**KO865 – KELLEY STUDENT –
Replace Building Sewer Line Near Activity Ctr/Restrooms
IU PROJECT NO. 20240669
MSKTD Project No. 8241**

ADDENDUM NO. 1

APRIL 8, 2026

First Floor Kitchen Plumbing Demolition Plan
1/4" = 1'-0"

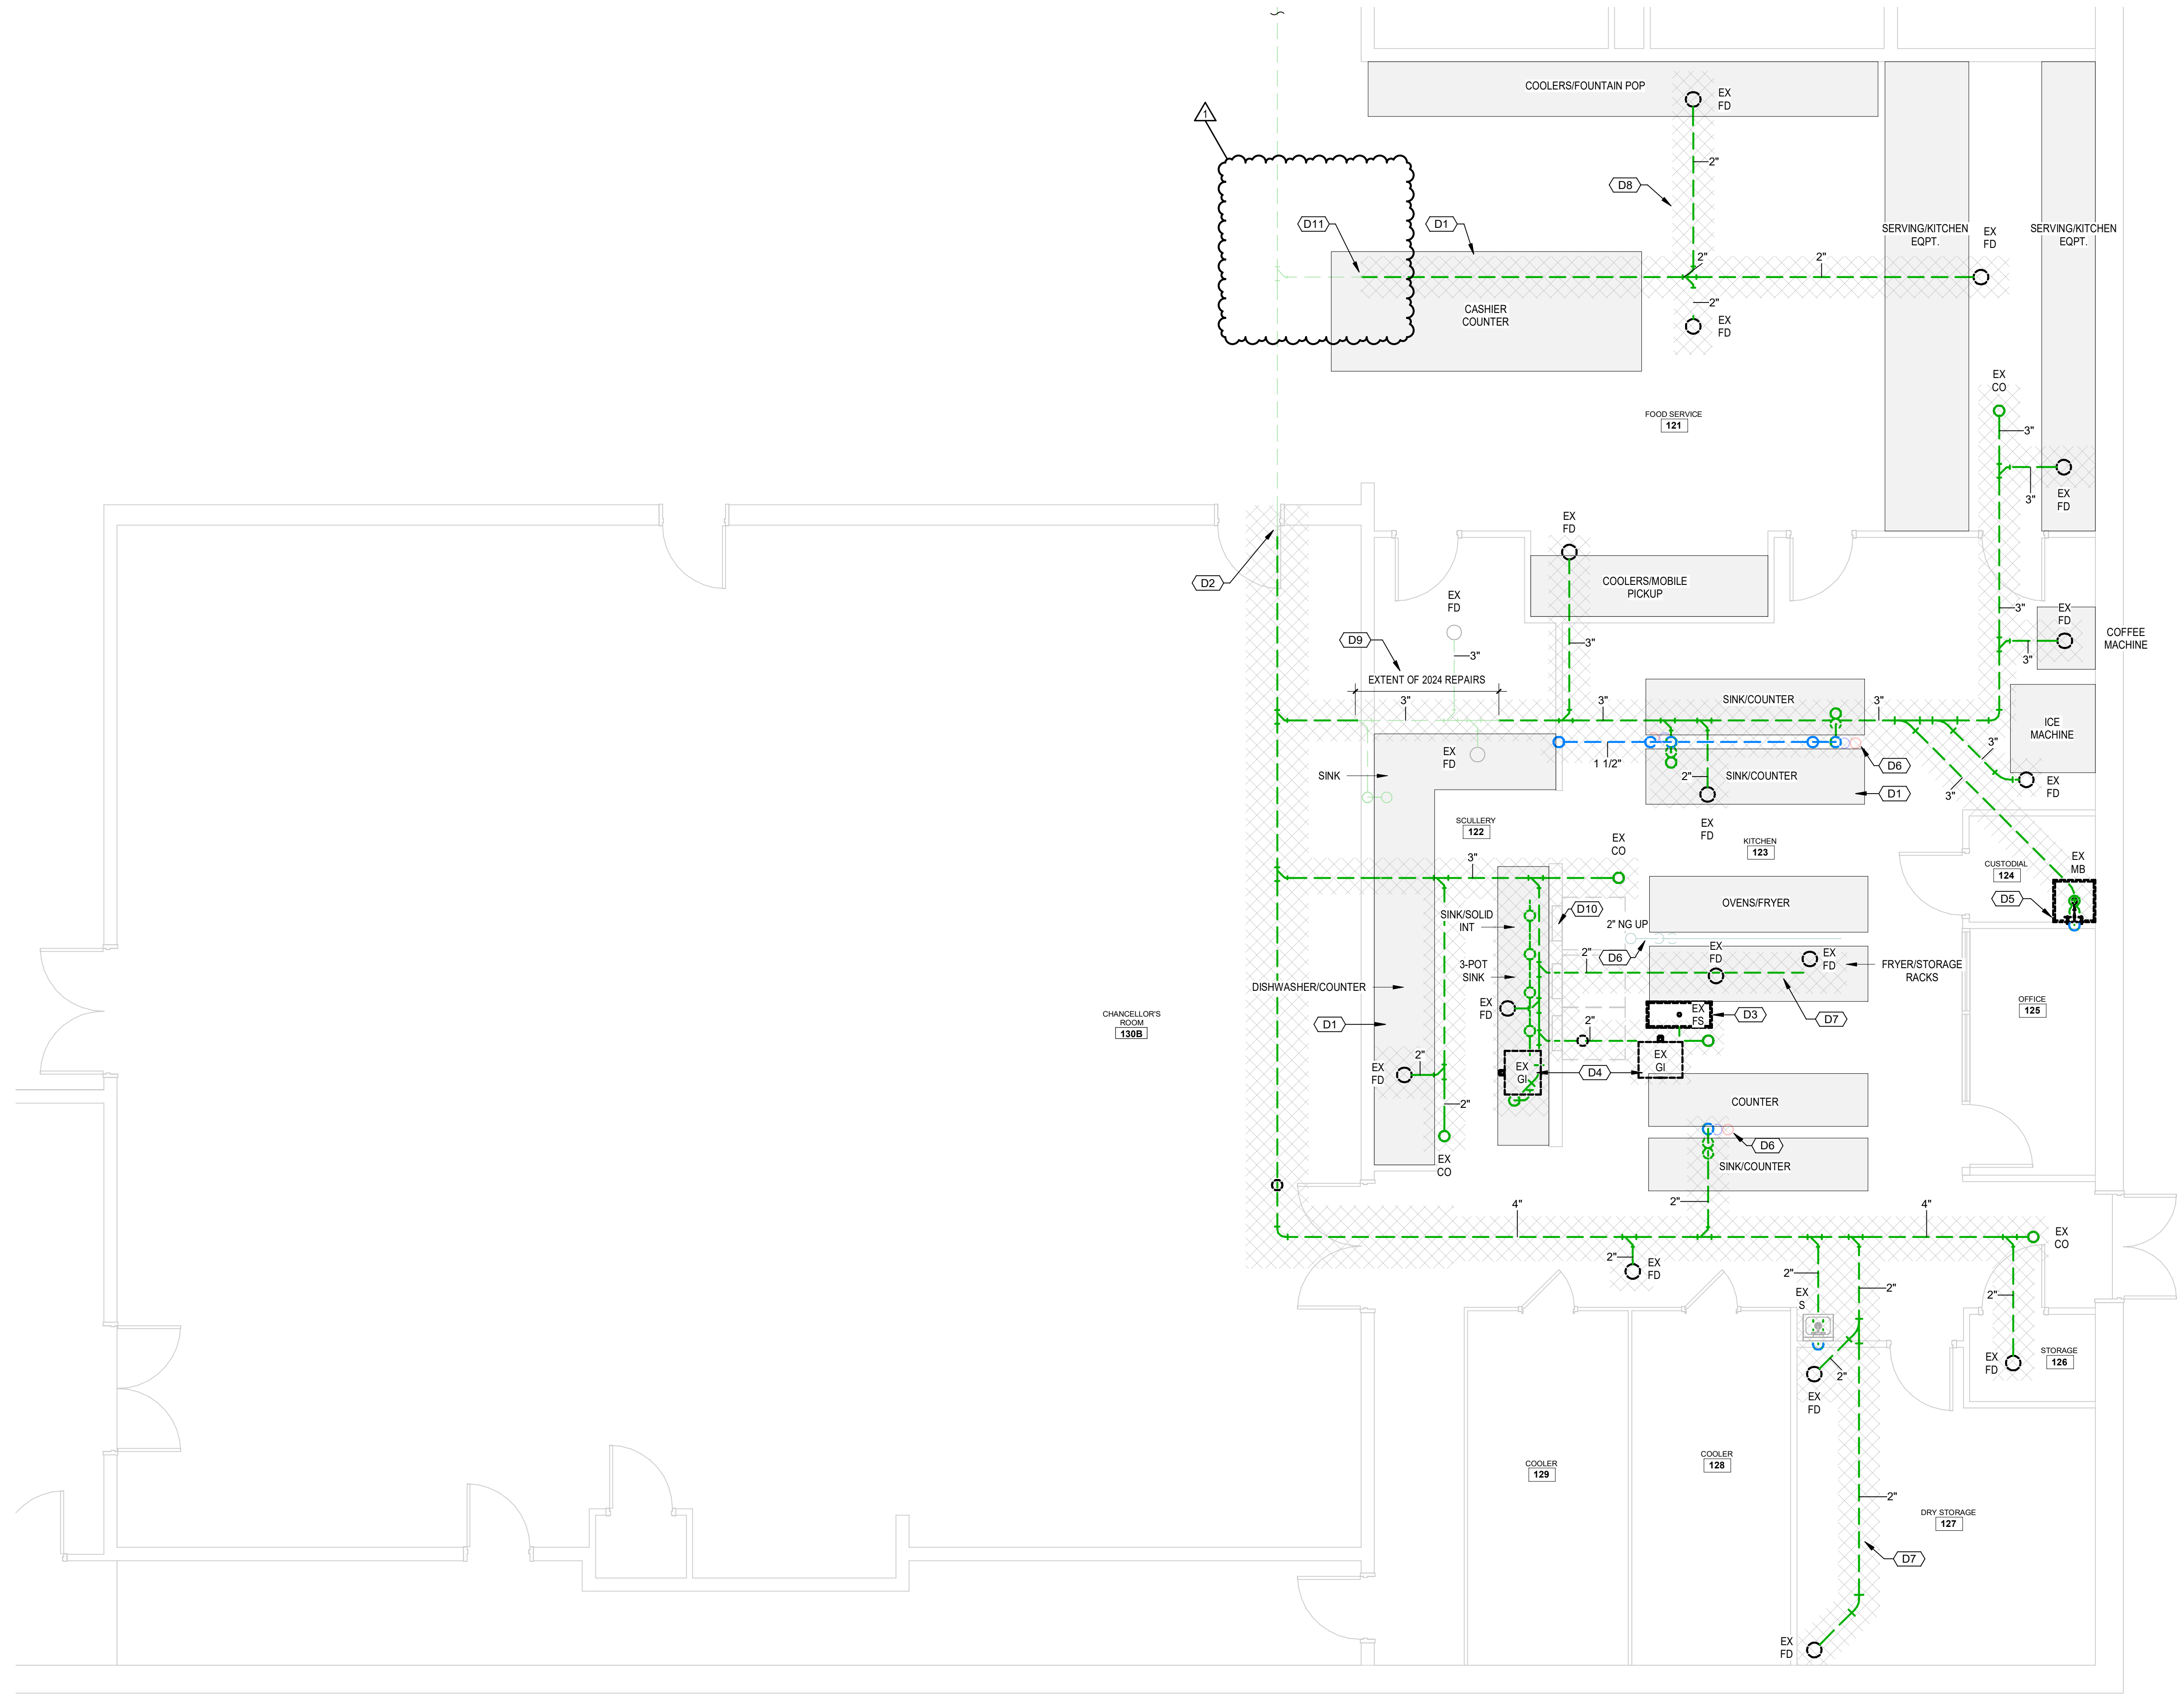
1.3 See attached, revised Sheet P101.
Adjustment of piping demolition extent to avoid interfering with existing flooring outside of scope.

D9	HALFTONED PIPE IN THIS ARE REPRESENTS POSSIBLE LOCATION OF 2024 REPAIRED SANITARY PIPING. VERIFY IN FIELD EXTENT OF PIPING. DO NOT REMOVE REPAIRED 2024 PIPING WHERE POSSIBLE.
D10	EXISTING ELECTRICAL PANELS ON THIS WALL. THERE IS A HIGH PROBABILITY OF ENCOUNTERING ELECTRICAL CONDUIT DURING SAWCUTTING OF FLOOR. REFERENCE ELECTRICAL DRAWINGS FOR INSTRUCTIONS ON HOW TO PROCEED WITH CONDUIT.
D11	DISCONNECT AND REMOVE ALL UNDERGROUND SANITARY PIPING, FLOOR DRAINS, CLEANOUTS UP STREAM OF THIS LOCATION. AVOID DAMAGING VINYL FLOORING OF AREA WEST OF FOOD SERVICE 121.

First Floor Kitchen Plumbing Plan
1/4" = 1'-0"

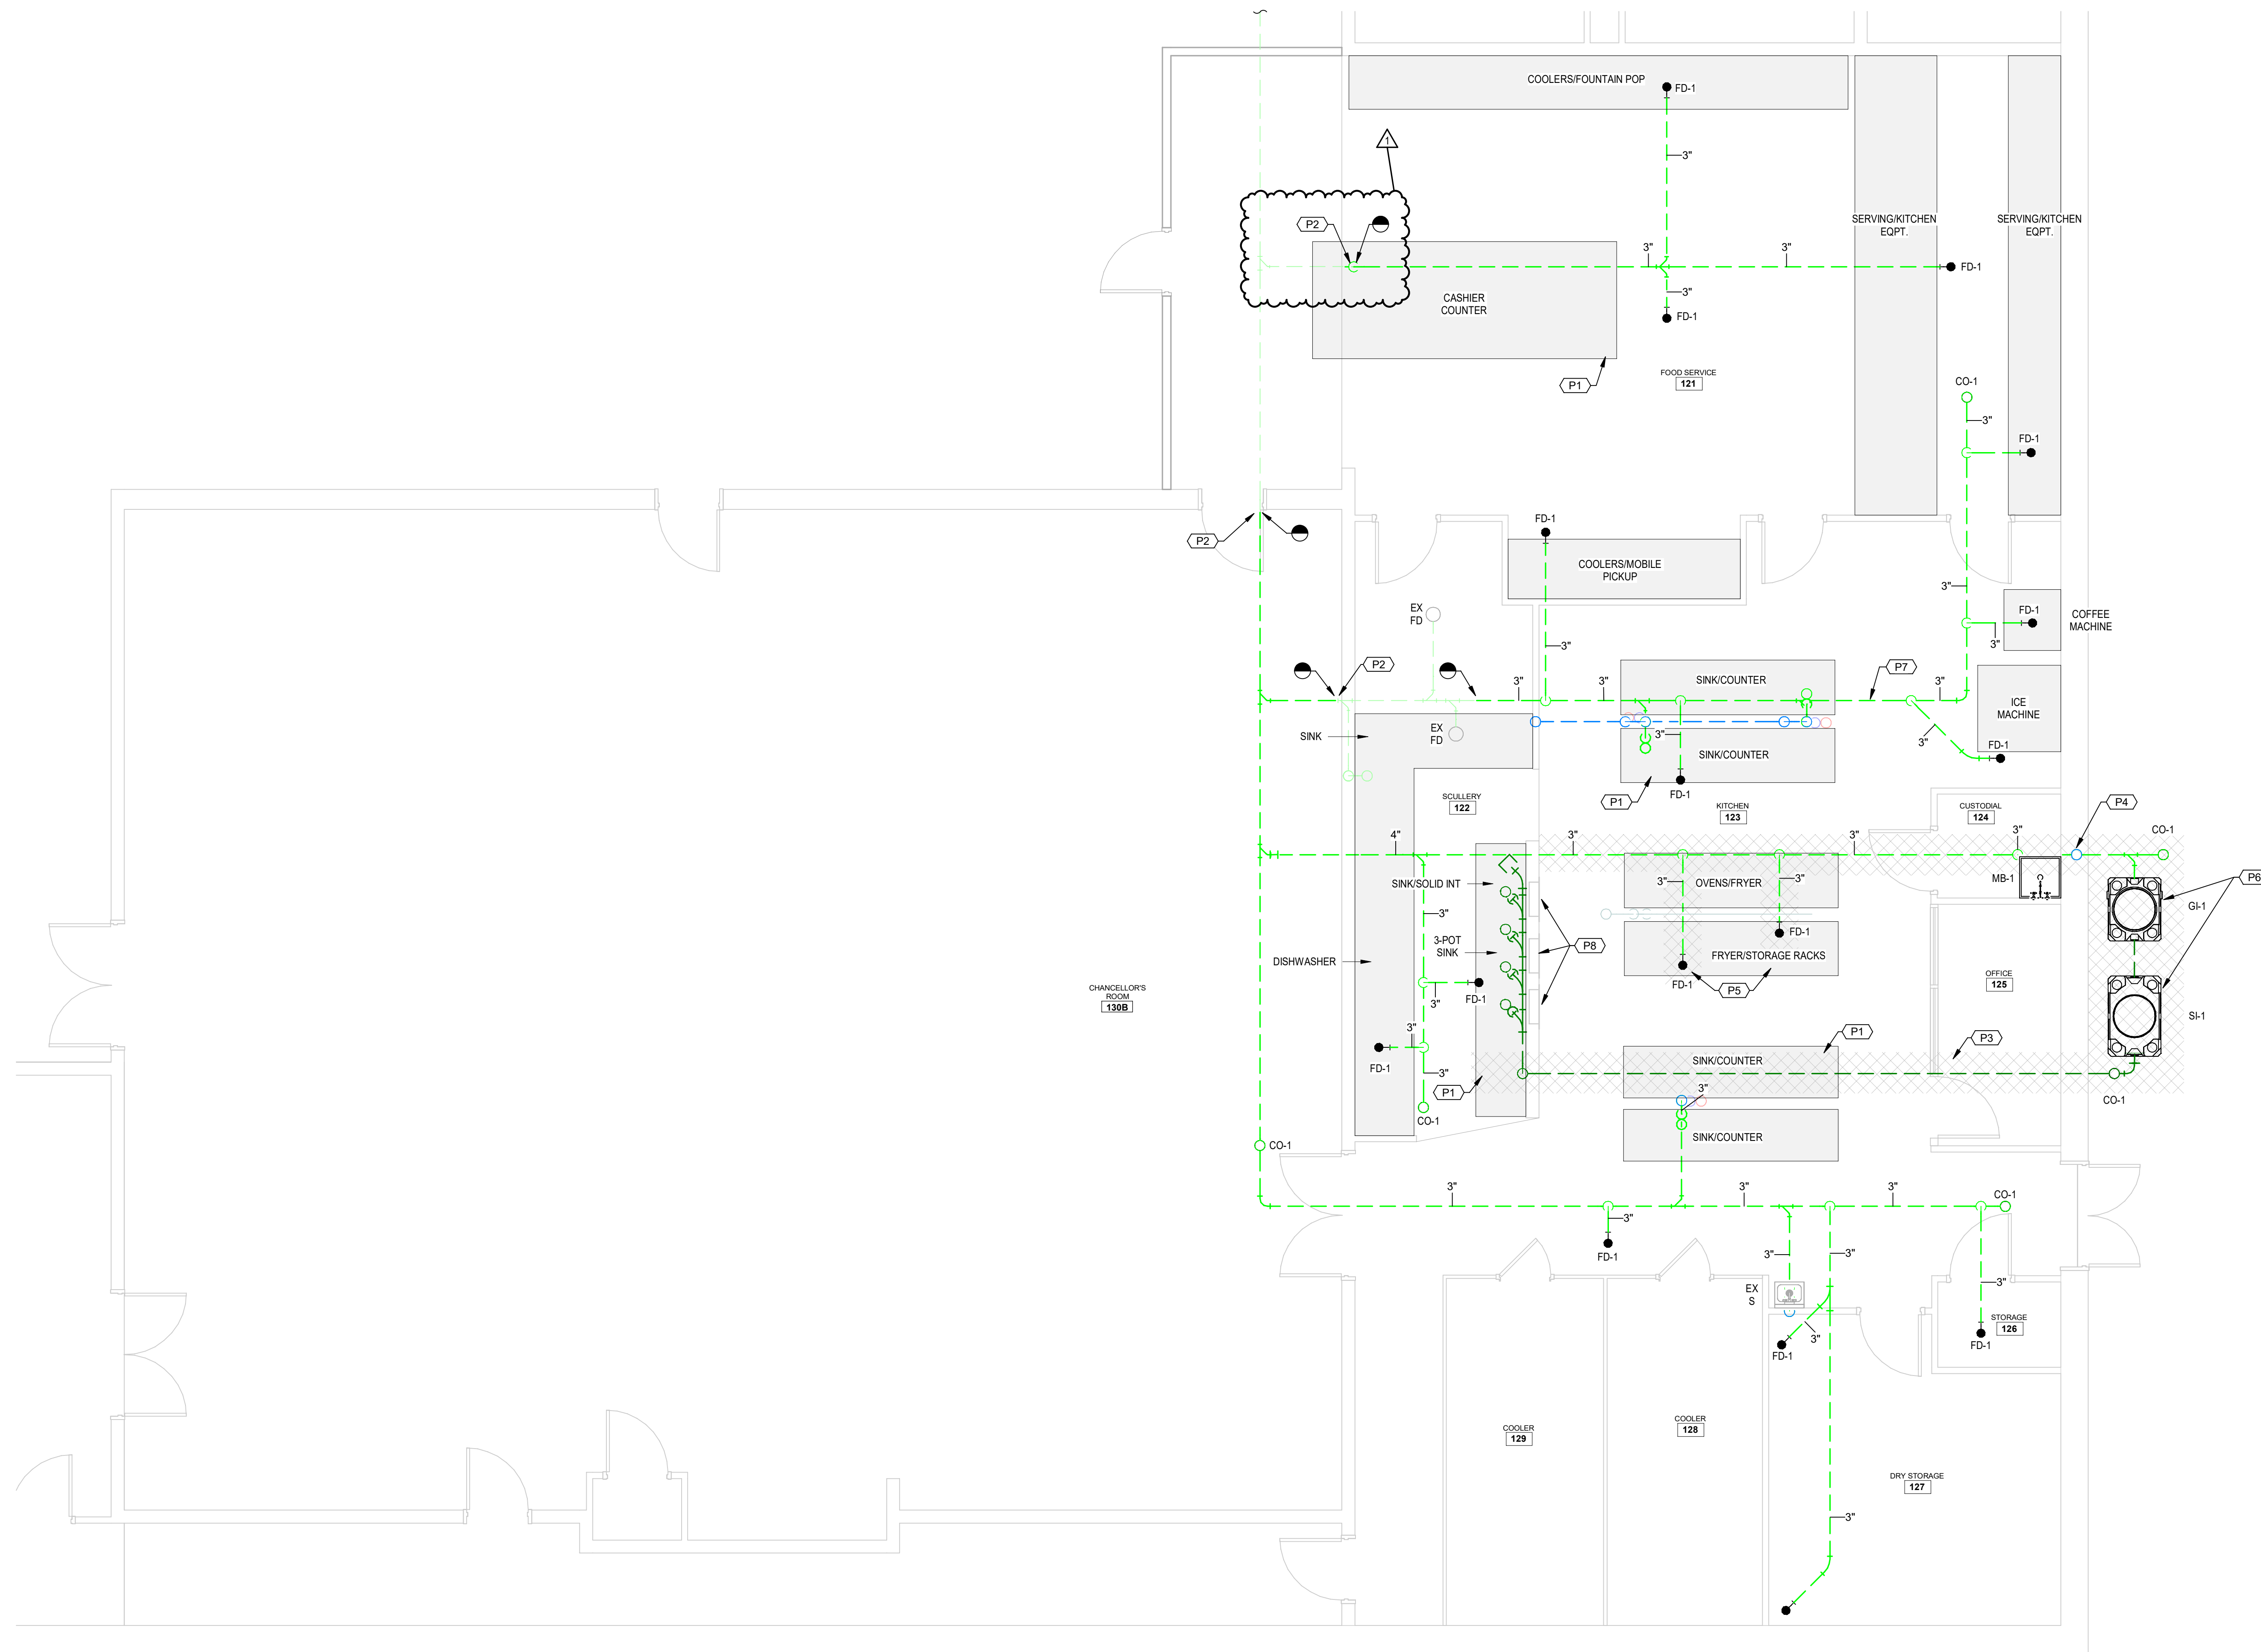
1.4 See attached, revised Sheet P201.
Adjustment of connection point of new piping to avoid interfering with existing flooring outside of scope.

Specific Plan Notes	
P1	ALL ABOVE SLAB EQUIPMENT NOTED BY FILLED REGION TO BE PLACED AND RECONNECTED BY OWNER
P2	CONNECT NEW PIPING TO EXISTING PIPING.
P3	DIAGONAL CROSS HATCHING REPRESENTING POTENTIAL SAWCUTTING FOR NEW FATS, OILS, GREASE SANITARY LINE TO OUTDOOR GREASE/SOLIDS INTERCEPTORS - AND BACK TO BUILDING TIE IN POINT.
P4	2" VENT PIPING FOR GREASE INTERCEPTOR. COMBINE WITH VENT SERVING MOP BASIN. VERIFY LOCATION IN FIELD - DISCREPANCIES BETWEEN EXISTING DRAWINGS. IF EXISTING VENT LINE IS WITHIN WALL AND NOT ACCESSIBLE, RUN NEW VENT LINE UP EXTERIOR OF WALL 10-FEET ABOVE GRADE. PAINT TO MATCH SURROUNDINGS.
P5	EXISTING DRAWINGS ARE UNCLEAR NEAR THESE TWO FLOOR DRAINS. SAWCUTTING MAY OR MAY NOT BE REQUIRED.
P6	INSTALL PER MANUFACTURER'S RECOMMENDATIONS - INCLUDING REQUIRED BACKFILL AND PATCHING OF CONCRETE.
P7	TYPICAL. ALL PIPING BELOW SLAB TO BE NOMINAL PIPE SIZE OF 3" OR LARGER.
P8	EXISTING ELECTRICAL PANELS ON THIS WALL. THERE IS A HIGH PROBABILITY OF ENCOUNTERING ELECTRICAL CONDUIT DURING SAWCUTTING OF FLOOR. REFERENCE ELECTRICAL DRAWINGS FOR INSTRUCTIONS ON HOW TO PROCEED WITH CONDUIT.
